City of Portland, Maine – Building or Use Permit Application 389 Congress Street, 04101, Tel: (207) 874-8703, FAX: 874-8716

Location of Construction: 80 Roberts Street Portland		Owner: Elizabeth Henry Griffin		Phone: *772-8313 **795-9029		Permit No: 990654	
Owner Address: SAA		Lessee/Buyer's Name:		Phone:		BusinessName:	
Contractor Name:		Address:		Phone:		<div style="border: 2px solid black; padding: 5px; text-align: center;"> PERMIT ISSUED JUN 23 1999 </div>	
Past Use: 2 family		Proposed Use: same		COST OF WORK: \$ 2,000.00 PERMIT FEE: \$ 30.00		INSPECTION: Use Group A3 Type 5B BOCA 96 Signature: [Signature]	
Proposed Project Description: Replace supports flooring of existing front porch on existing footprint		PEDESTRIAN ACTIVITIES DISTRICT (P.A.D.) Action: Approved <input type="checkbox"/> Approved with Conditions: <input type="checkbox"/> Denied <input type="checkbox"/>		Signature: [Signature]		Date:	
Permit Taken By: KA		Date Applied For: June 17, 1999 KA				Zoning Approval: [Handwritten] Special Zone or Reviews: <input type="checkbox"/> Shoreland <input type="checkbox"/> Wetland <input type="checkbox"/> Flood Zone <input type="checkbox"/> Subdivision <input type="checkbox"/>

CONSTRUCTION PLAN 80 Roberts St.

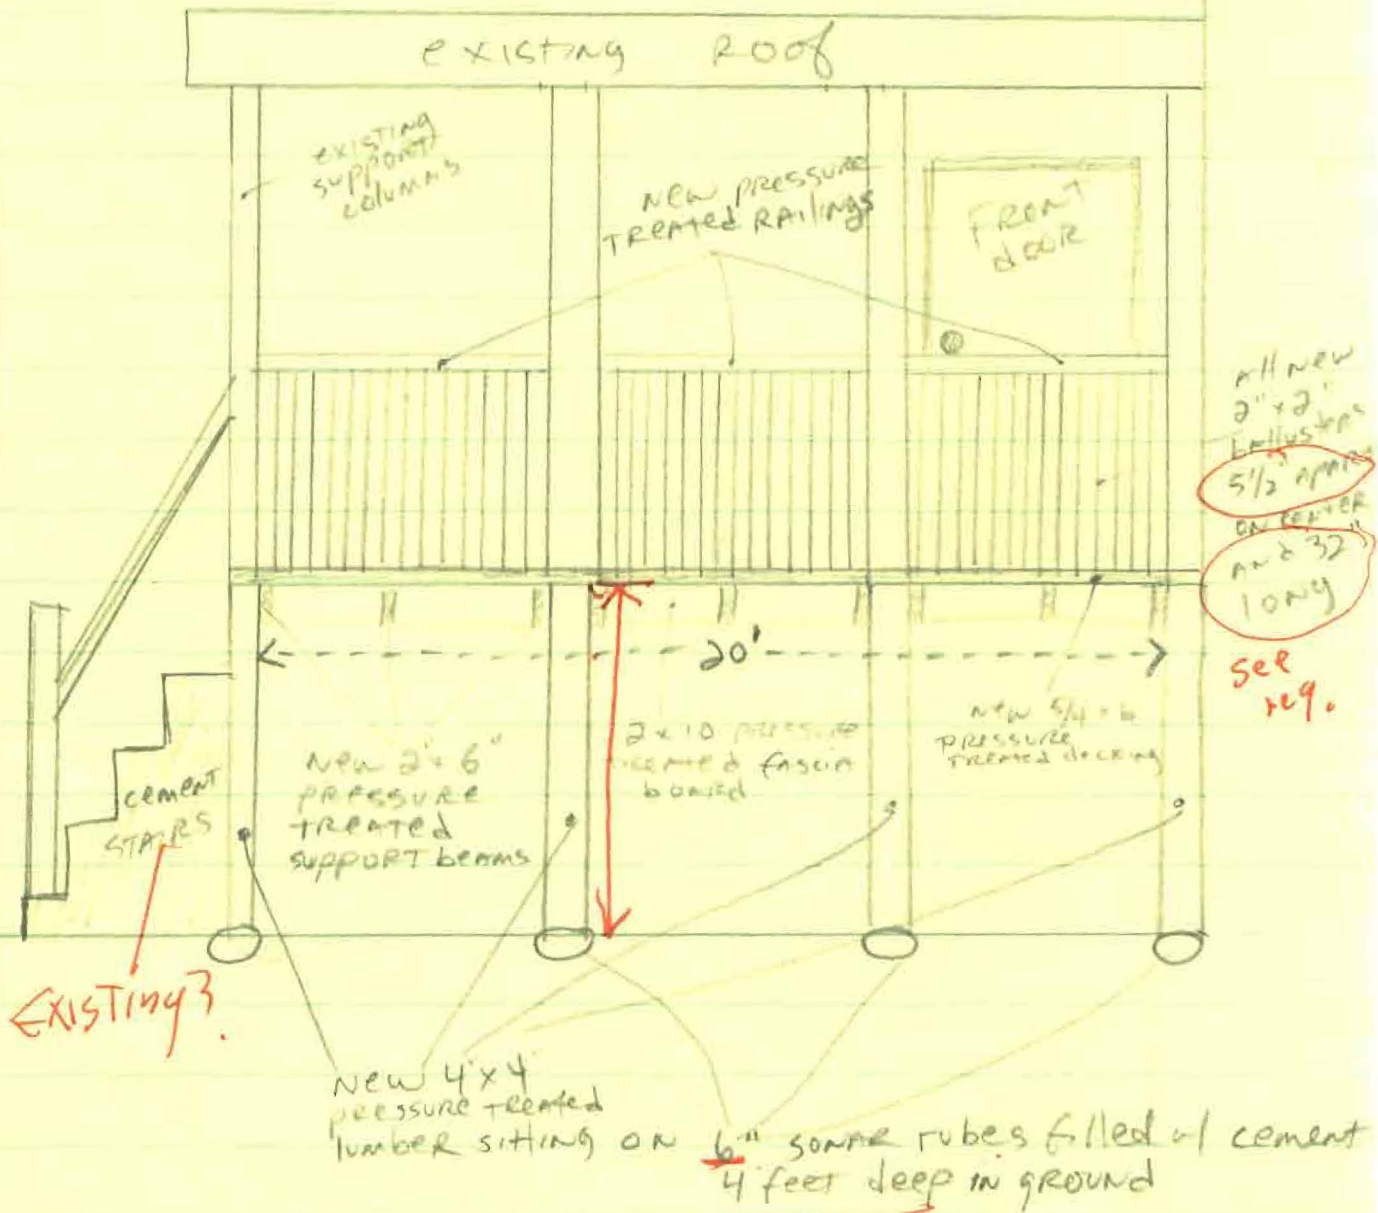
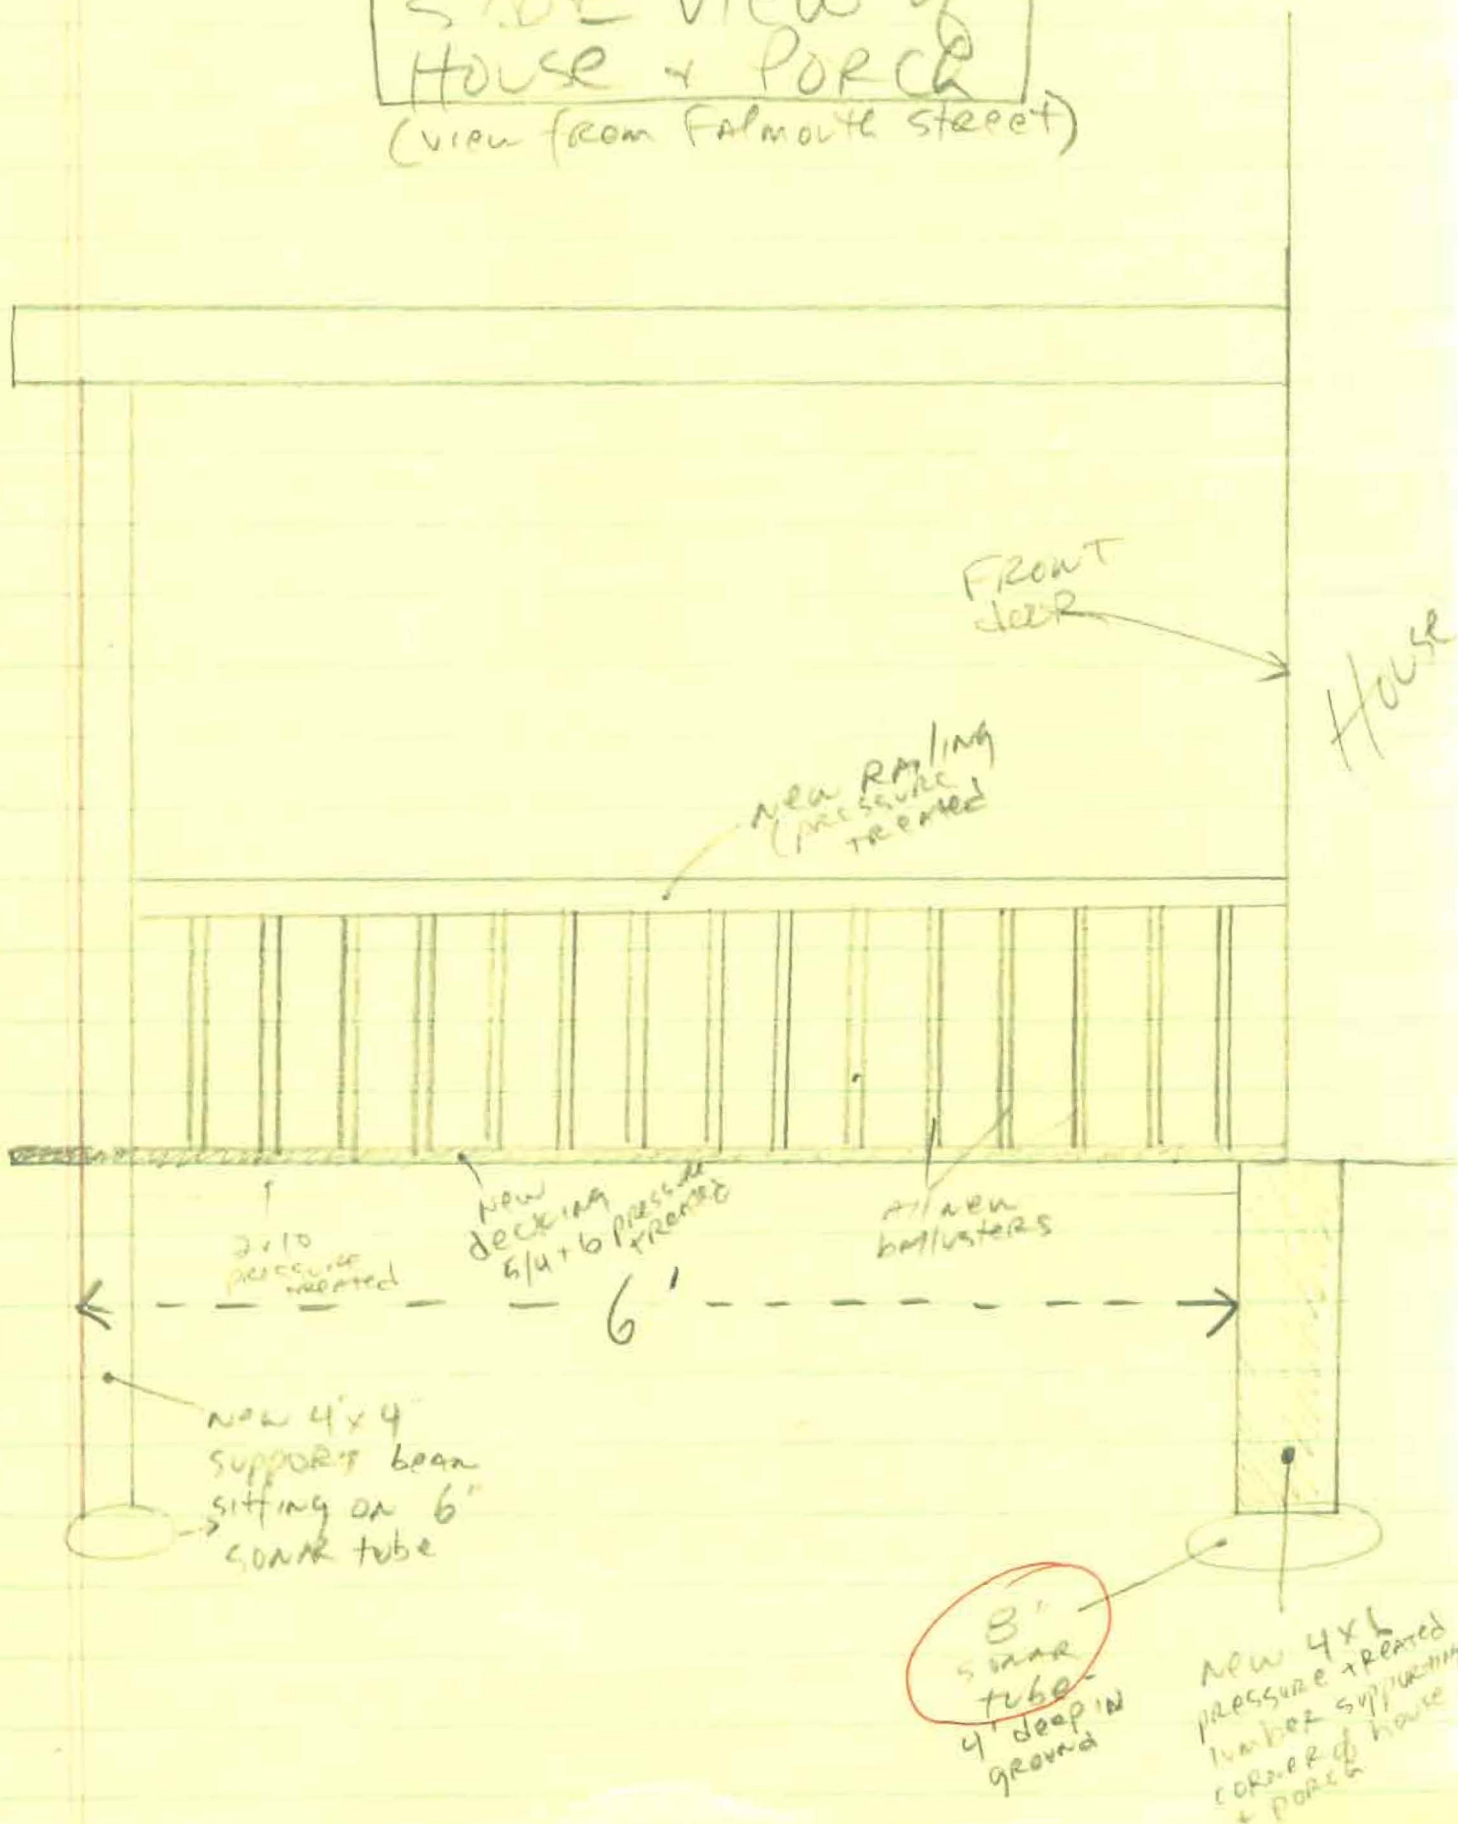
33. Glass and glazing shall meet the requirements of Chapter 24 of the building code
- * 34. The proposed 6" pier (Soro Tube) Foundation shall rest on a Footing with anchor connecting The Pier with Footing.

- * 35. The proposed 4x4" p.c. Columns shall be fasten to The piers -
- * 36. Bracing shall be required between columns.
- 37.
